OIL - REPLACEMENT OF TWO OIL SCAVENGE TUBES ON THE EXTERNAL GEARBOX - CATEGORY CODE 4
- MOD.ENG-79-0026

- (1) Aircraft: Airbus A320
- (2) Engine: V2500-A1 Engines prior to Serial No.V0213

V2500-ENG-79-0026

Oil scavenge tube replacement
Fig.1

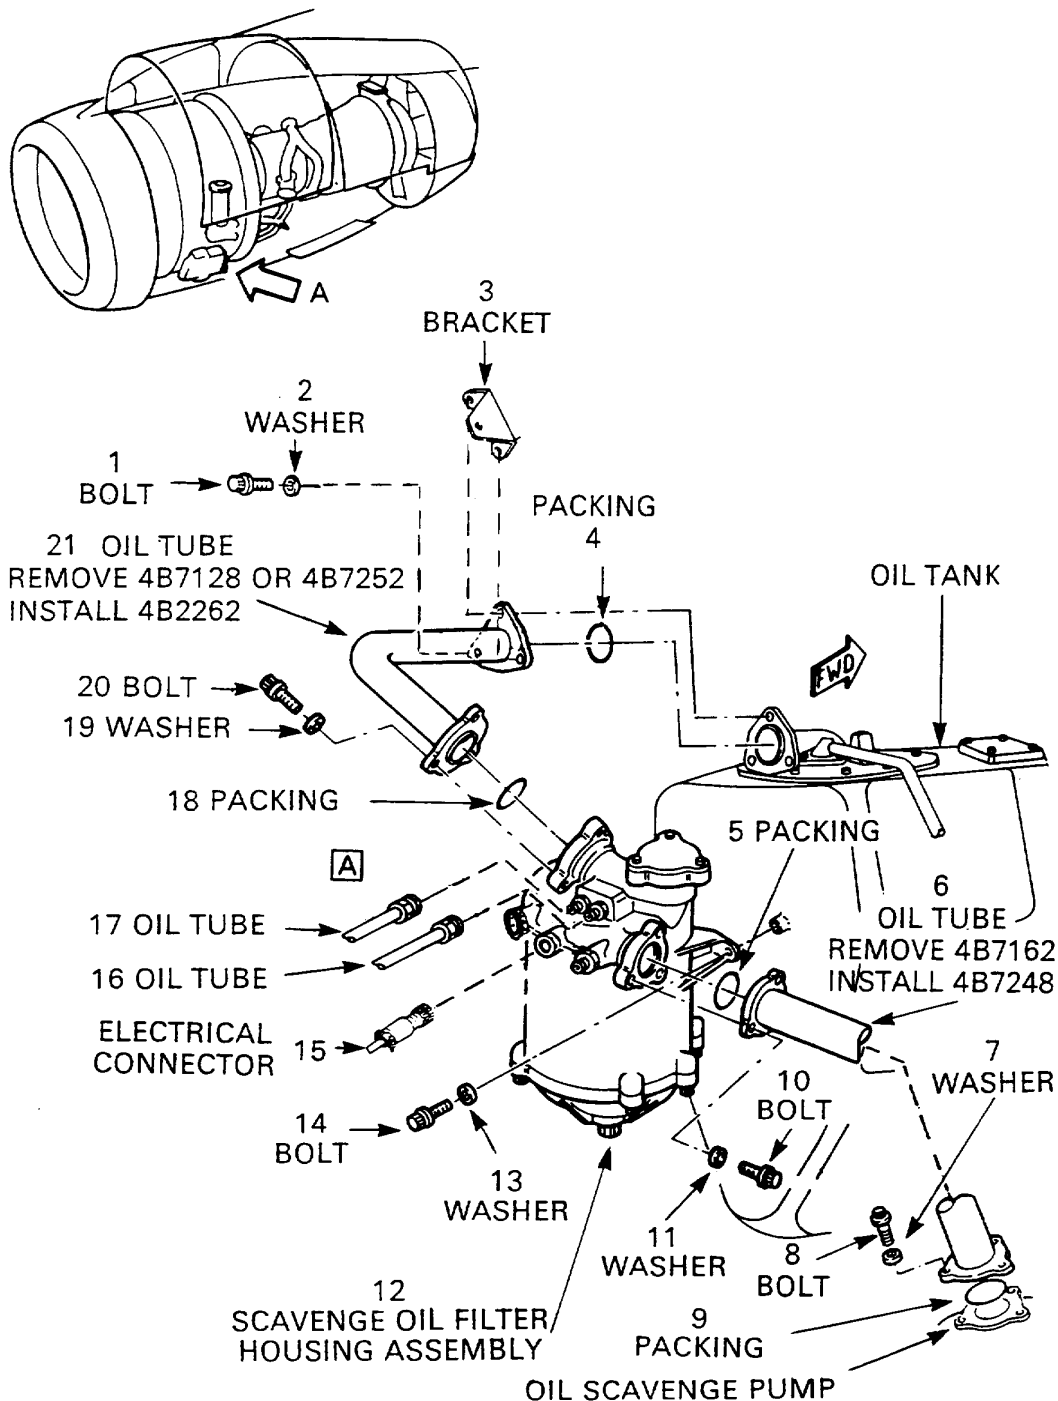
Cracks may potentially occur in welded joints of the end fittings resulting in oil leakage.

Investigation of cracked tubes showed dimensional nonconformances resulting in additional tensional loads.

Two scavenge tubes are replaced with two redesigned tubes.

- (1) Remove the 4B7128 or 4B7252 Oil Tube. Refer to Figure 1.
 - (a) Remove the three bolts (10) and the three washers (11).
 - (b) Remove the three bolts (1) the one washer (2) and the bracket (3) which attach the Oil Tube (21) to the Oil Tank.
 - (c) Loosen, but do not remove, the three bolts (20) which attach the Oil Tube (21) to the Scavenge Oil Filter Housing Assembly.
 - (d) Hold the Scavenge Oil Filter Housing Assembly and remove the three bolts (14) and the three washers (13).
 - (e) Remove the Scavenge Oil Filter Housing Assembly with the Oil Tube (21) from the Oil Tank.
 - (f) Remove the three bolts (20) and the three washers (19) and remove the Oil Tube (21) from the Oil Filter Housing Assembly.
 - (g) Remove and discard the packing (4) and (18).
- (2) Remove 4B7162 Oil Tube. Refer to Figure 1.

- (3) Discard 4B7128 or 4B7252 and 4B7162 Oil Tubes.
- (4) Install new 4B7248 Oil Tube. Refer to Figure 1.
 - (a) Install a new packings (9) and (5) on the flange of the tube seats, by the approved procedure in Reference (1), Chapter/Section 70-23-13, Maintenance Practices.

- (e) Tighten the bolts by hand.
 - (f) If required, Install oil tank by the approved procedure, Reference (1), Chapter/Section 79-11-41.
- (5) Install new 4B2262 Oil Tube. Refer to Figure 1.

- (f) Install the three bolts (14) and the three washers (13). Tighten the bolts (14) by hand.
- (g) Install the three bolts (1) the one washer (2) and the bracket (3) to attach the Oil Tube (21) to the Oil Tank.
- (h) Torque the bolts (14) to between 85 and 95 lbfin (9,6 to 10,7 Nm) (Refer to Aircraft Maintenance Manual Chapter/Section 70-23-11, Torque Tightening Technique).
- (i) Torque the bolts (1) and (20) to between 85 and 95 lbfin (9,6 to 10,7 Nm). (Refer to Aircraft Maintenance Manual Chapter/Section 70-23-11, Torque Tightening Technique).
- (j) Attach the Oil Tube (6) to the Scavenge Oil Filter Housing assembly using the three bolts (10) and the three washers (11).
- (k) Torque the bolts (10) and (8) to between 85 and 95 lbfin (9,6 to 10,7 Nm). (Refer to Aircraft Maintenance Manual Chapter/Section 70-23-11, Torque Tightening Technique).
